Intel[®] Communications Chipset 8900 Series

Specification Update

May 2014

Document Number: 328000-005US

Figure 2. 1000BASE-BX/FC-PI Transmitter Electrical Specifications

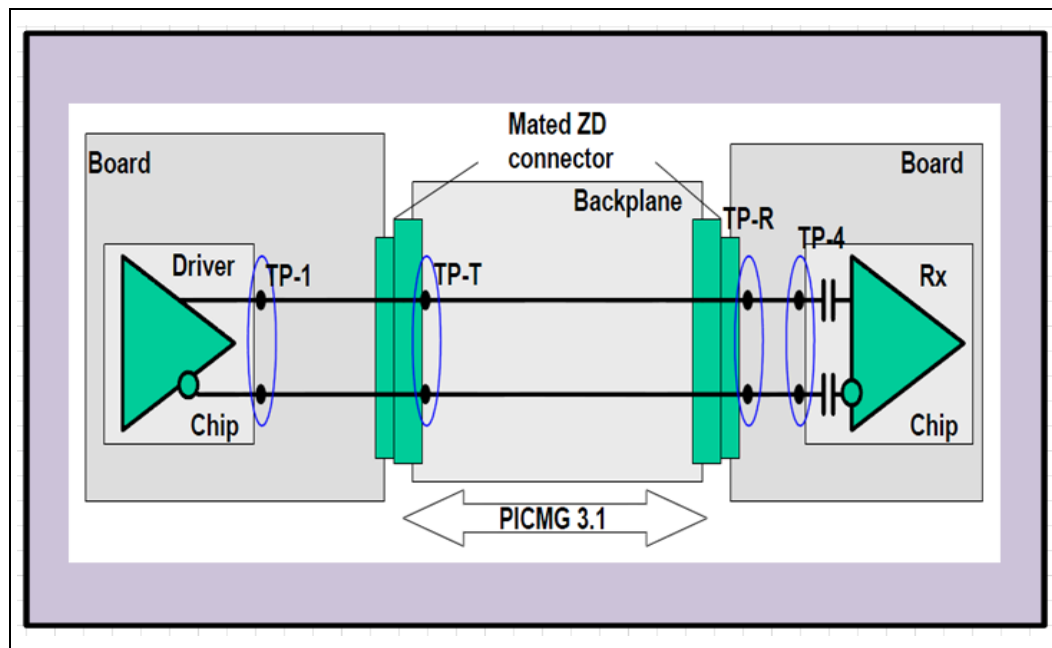
Implication: Although this is a specification violation, it does not affect the functional operation of the interface.

Workaround: Ensure that the signal routing length from TP-1 to TP-4 is greater than 10". Refer to *Intel® Communications Chipset 8900 Series Platform Design Guide (PDG)* for maximum routing length. (See [Figure 2.](#))
